**CITY OF TEMPE
DEVELOPMENT REVIEW COMMISSION**

**Meeting Date: 01/08/2013
Agenda Item: 6**

ACTION: Request for a Development Plan Review consisting of replacement of an existing restaurant with a new +/-4,316 sf. restaurant and drive-thru for McDONALDS (PL120398) located at 1525 West Elliot Road. The applicant is Synectic Design, Incorporated.

DEVELOPMENT PROJECT FILE
for
McDONALD'S at ELLIOT & PRIEST

LANDSCAPE PLAN
 XXXX (PLANNING/ZONING)
 TITLE: MCDONALDS ELLIOT AND PRIEST
 SHEET NO.: 10.1

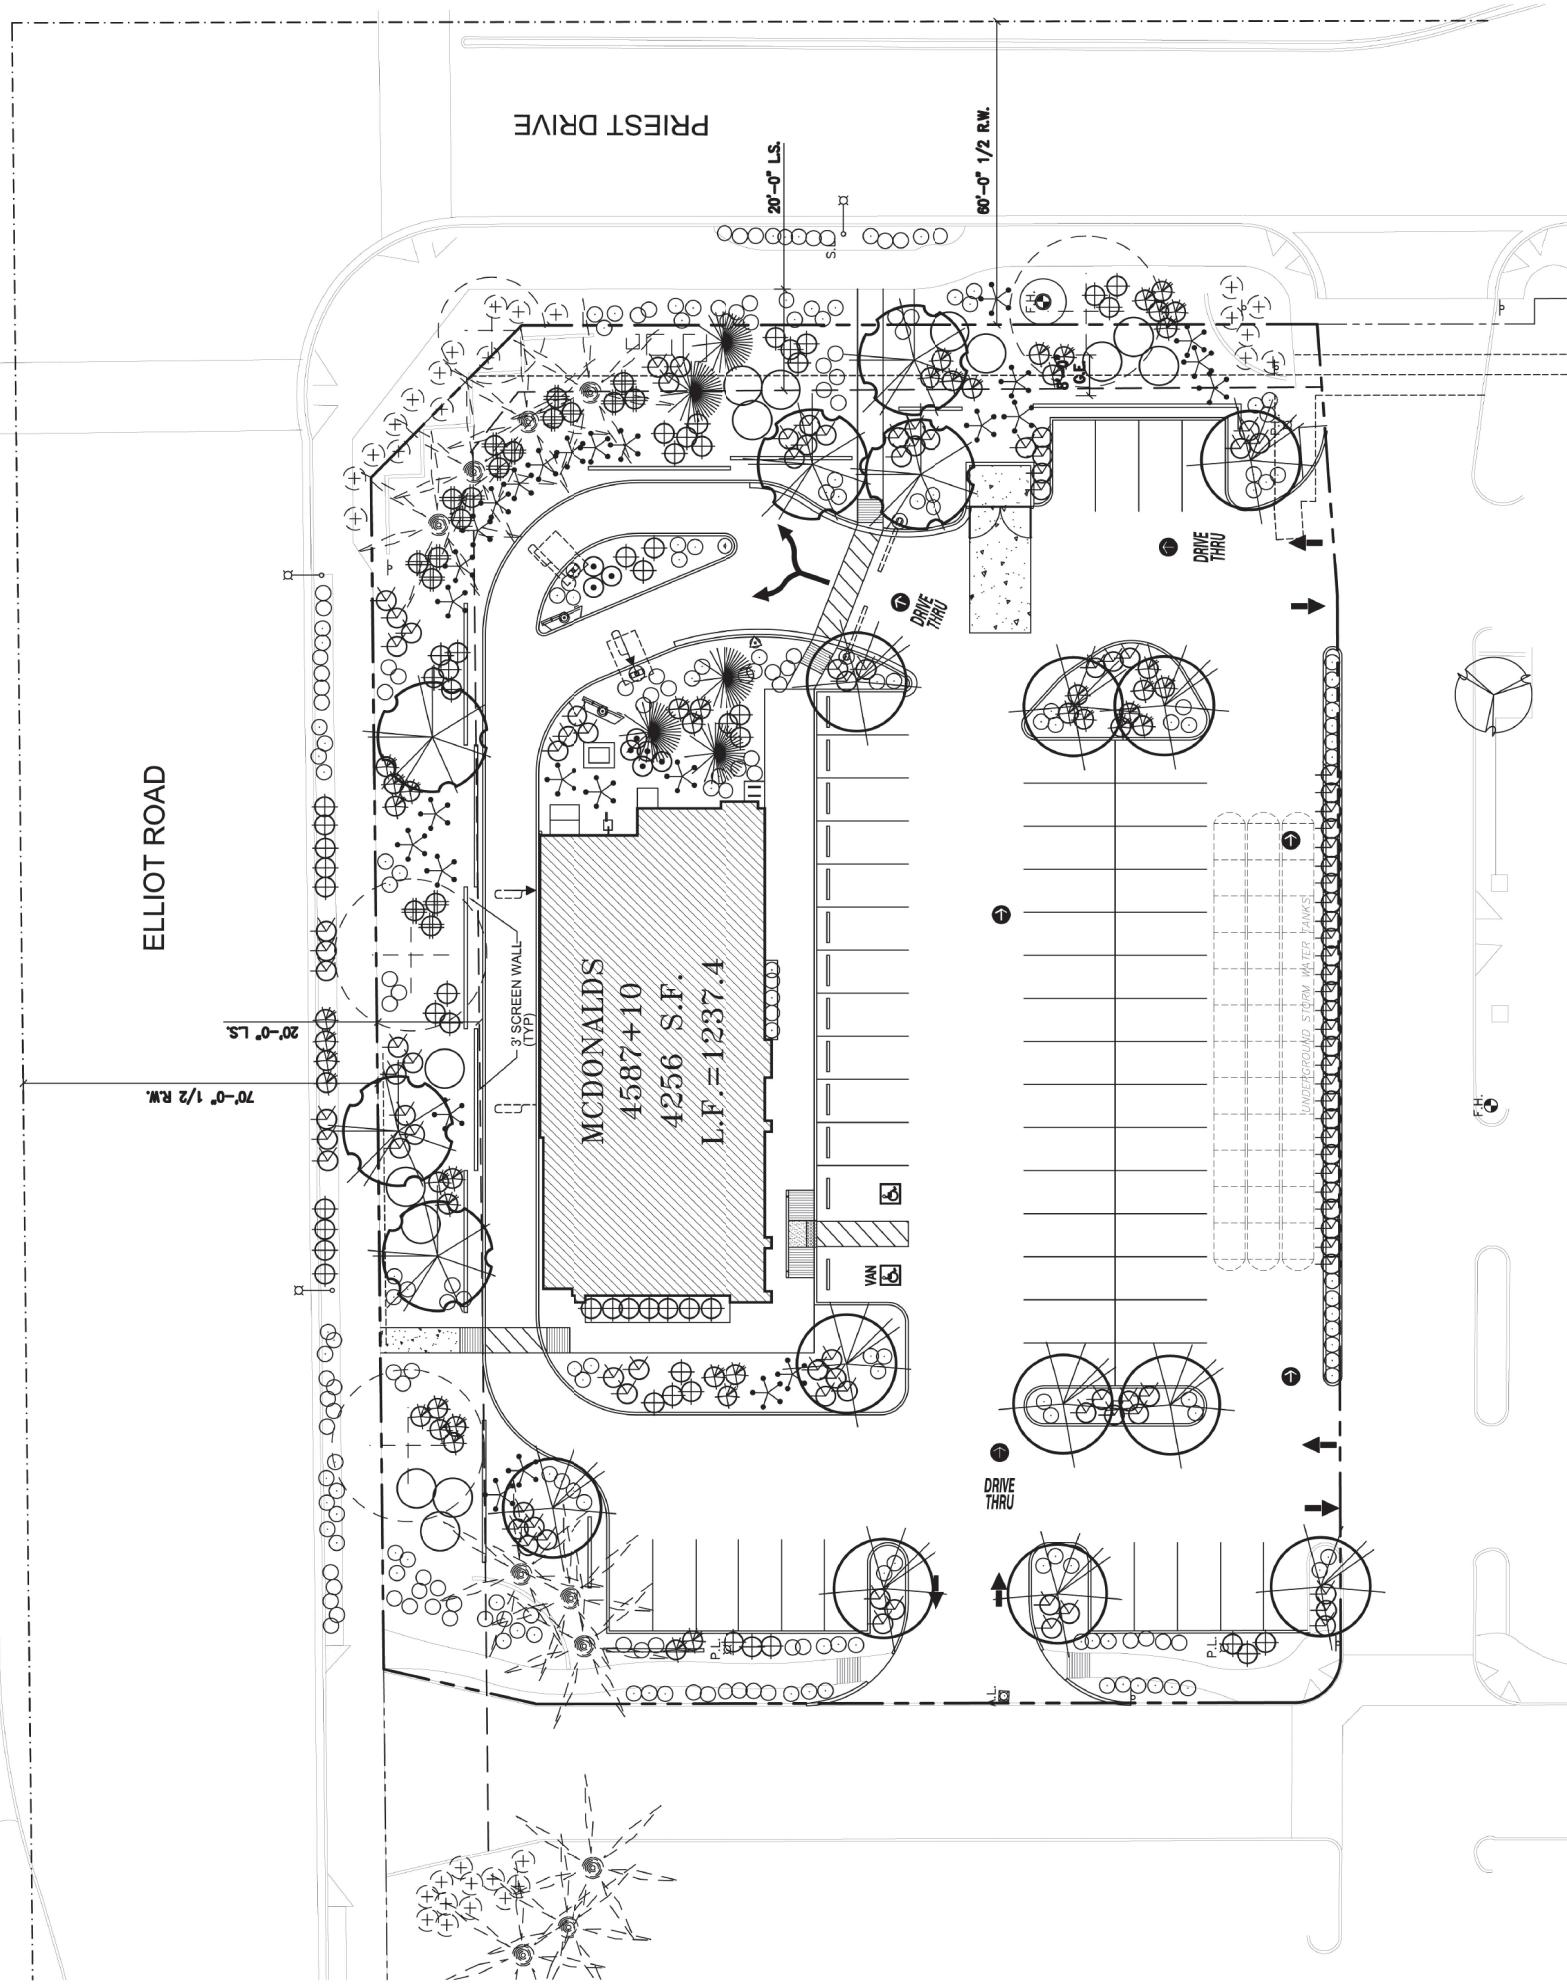
14. Maintain minimum 20'-0" wide on site landscape buffer between Elliot and Priest right of way and drive-thru. Indicate "existing plant material to be protected during construction" by species. Where an existing tree or palm indicated to remain dies or shows probability of dying prior to conclusion of this project, replace with a minimum 36" box tree or 20'-0" brown trunk palm that compliments the landscape design.

- On landscape plan, correctly indicate driveway clear vision triangles that cross Pad B. Identify speed limit for Elliot Road and Priest Drive at site frontages. Consult Transit Studies Division Corner Sight Distance memorandum available at www.tempe.gov/modules/showdocument.aspx?documentid=6815 . Begin sight triangle in driveways at point 15'-0" in back of face of curb. Do not locate site furnishings, screen walls or other visual obstructions over 2'-0" tall (except canopy trees are allowed) within each clear vision triangle.
